## **Planning Commission Staff Report**

**Subject:** Zoning Map Amendment Vote Report

**Petition:** **P.Z. 08-2013 – 16889 Chesterfield Airport Rd.**

PRELIMINARY DEVELOPMENT PLAN  
 LOCATOR # 177230189  
 BASE MAP # 171  
 VOLZ JOB# 11276-1  
 H:\CAD\11200-11289\11276\Planning\PPD.dgn  
 REVISED 5-31-2013  
 04-11-2013

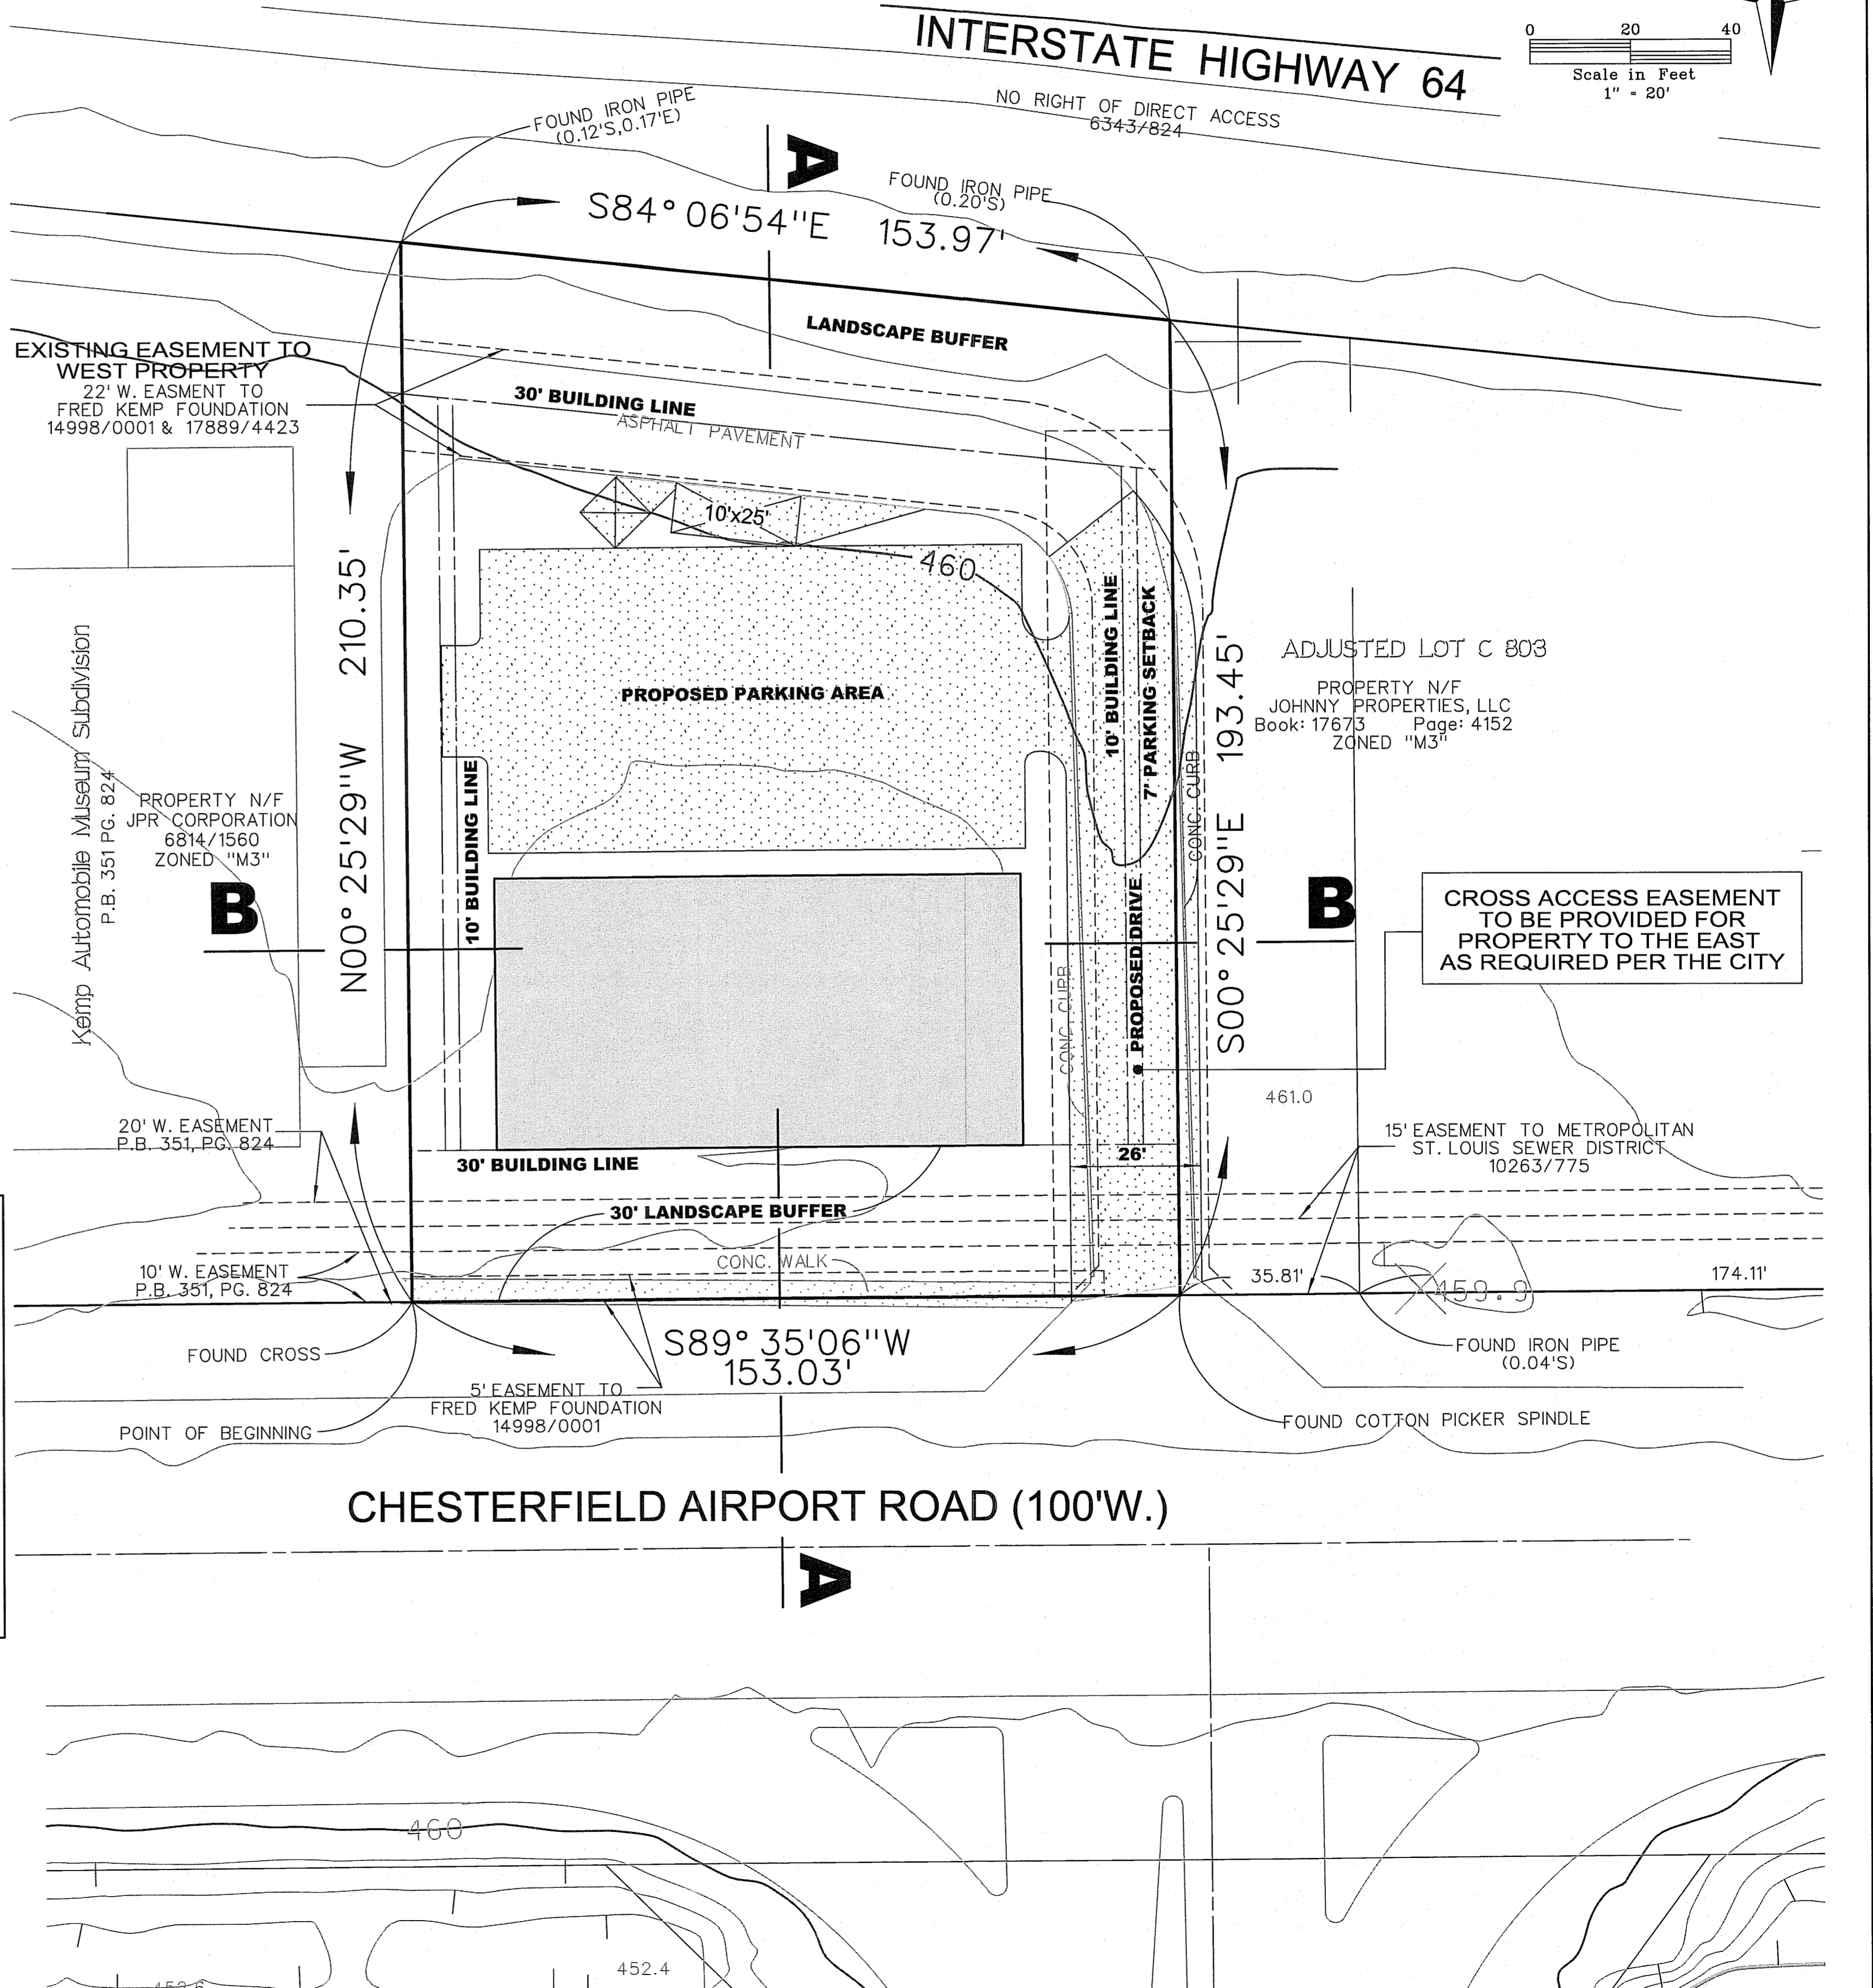
A public hearing was held on this request on May 13, 2013. At that time there were no speakers on this matter other than the petitioners. At the hearing, issues were identified. Those issues along with the Petitioner's responses are attached. There are no additional outstanding issues at this time.

Issue 2: The parallel spaces adjacent to the existing access road have been eliminated from the proposed Preliminary Development Plan, eliminating the need to research parking on the north side of the access drive.

Issue 3: There will be signs posted on the access drive that read **“NO PARKING ON INTERNAL ACCESS DRIVE.”**
